REPORT OF TEST

USATECOM PROJECT NO. 4-3-1000-02-A

MILITARY POTENTIAL TEST OF COMMERCIAL OFF-THE-SHELF  
HELICOPTERS AS BASIC ROTARY-WING INSTRUMENT TRAINERS

Figure 1

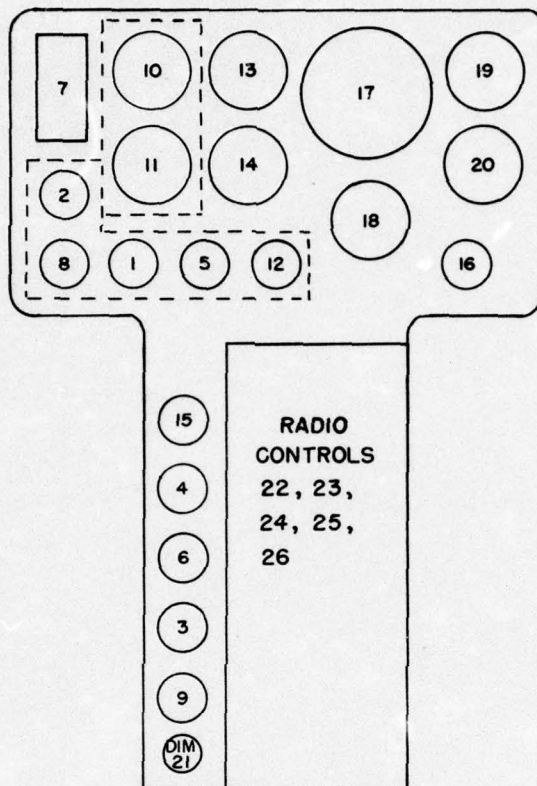
2.2 It appears that a number of indicators are unnecessarily placed on the upper instrument console. Without these the basic instrument group could be moved closer to the instructor. This is considered desirable, since it will provide a less oblique view of the basic instrument group by the instructor. It should also reduce the clutter of the basic panel.

2.2.1 Figure 1 indicates a panel that, without consultation with instrumentation engineers, is considered preferable.

2.2.1.1 In this proposed location, it would be desirable to provide a lock for the ignition switch. It definitely should not be located adjacent to the AN/ARC45 control.
